## Calculation/Analysis Change Notice

3. Document Identifier: <b>200-PSA-RF00-00100-000-00A</b>		4. Rev.: 00A	5. CACN: 002
6. Title: <b>Receipt Facility Event Sequence Development Analysis</b>

7. Reason for Change: Change text of fifth bullet on page 13 per Condition Report 11989 Corrective Action 003. Provide for increased clarity and traceability by filling in blank cells in tables in response to Condition Report 12105 Corrective Action 011. Rectify lack of traceability in MLDs for precursor events identified in the HAZOP in response to Condition Report 12121 Corrective Action 007. Correct event trees in 200-PSA-RF00-00100-000-00A to agree with 200-PSA-RF00-00200-000-00A.

Figure D-10. Exposure During Cask Lid Removal and Installation of DPC Lift Fixture (DPC Only)

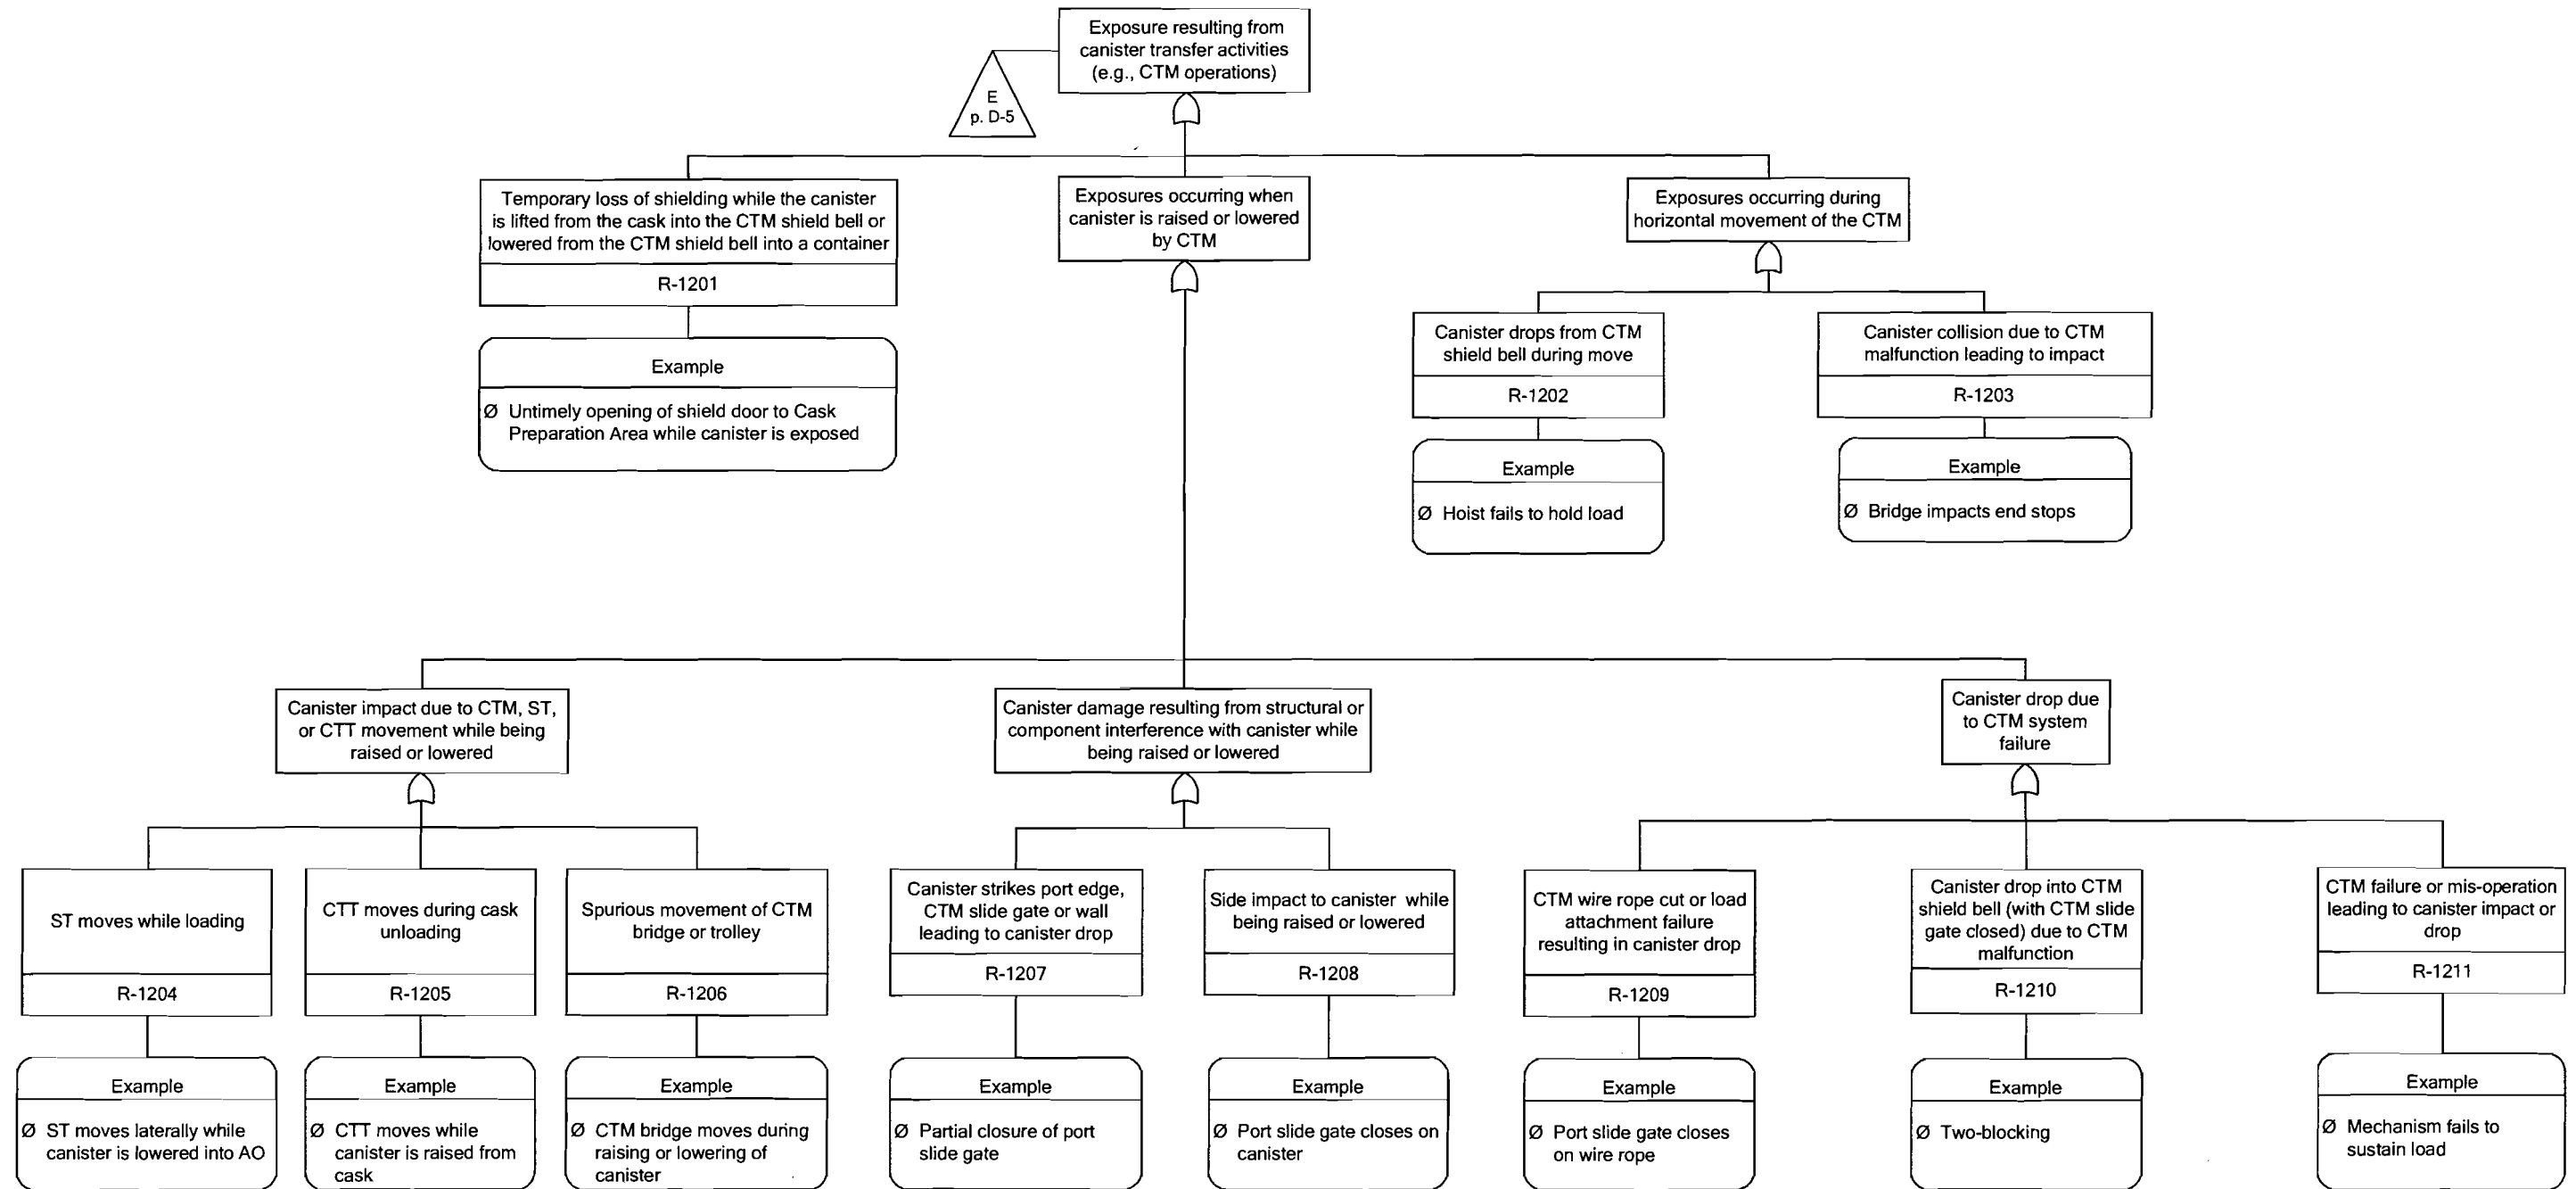
10. Description of Change: To resolve CR 11989, Action 003, the fifth bullet on page 13 is replaced by the following: <ul style="list-style-type: none"><li>• Intentional malevolent acts, such as sabotage and other security threats, were considered in a separate safeguards and security analysis performed by others.</li></ul> To resolve CR 12105, Action 011, the blank cells in Table 10, with the exceptions summarized in the next paragraph, are filled with em-dashes, indicating that no data belonged in those cells. Also to resolve CR 12105, Action 011, the blank cells in Tables E-2 through E-15, with the exceptions summarized in later paragraphs, are filled with em-dashes, "NCI" (for No Cause Identified), or N/A, indicating that no data belonged in those cells. N/A in the MLD Index Number column replaced by em-dashes. To resolve CR 12105, Action 011, HAZOP Table Number E-12 is added for Internal Event Identifier R-1001 in Table 10. A footnote is added to explain why no ESD Figure Number is needed for Internal Event Identifier R-J311 in Table 10. To resolve CR 12105, Action 011, prevention/mitigation suggestions are entered in the "Potential Prevention/Mitigation Design of Operational Feature" column for Node Item Number 4.5 in Table E-5, Node Item Numbers 8.5 and 8.6 in Table E-9, and Node Item Number 12.2 in Table E-13. To resolve CR 12121, Action 007, MLD Index numbers are added in the last column of the tables for Node Item Numbers 9.3, 9.4, 9.5, 9.17, and 9-20 in Table E-10, Node Item Numbers 11.12, 11.17, and 11.18 in Table E-12, and Node Item Number 13.17 in Table E-14. Also to resolve CR 12121, Action 007, the descriptions of R-1003 and R-1209 in Figures D-10 and D-12, respectively, are generalized to accommodate additional links with the HAZOP tables. To resolve a discrepancy identified between 200-PSA-RF00-00100-000-00A and 200-PSA-RF00-00200-000-00A, Figures G-12 and G-13 in 200-PSA-RF00-00100-000-00A are changed to agree with the Event Tree descriptions in 200-PSA-RF00-00200-000-00A. For each of these, the entries, "ESD5 SCREENED OUT" and "ZERO," in the two blocks at the top left are replaced. "Number of DPCs handled during preclosure period" and "DPC" are entered into those two blocks in Figure G-12. "Number of TADs handled during preclosure period" and "TAD" are entered into those two blocks in Figure G-13. Change bar at the bottom of page 79 indicates a page break for Table 9 to remain, in its entirety, on page 80.
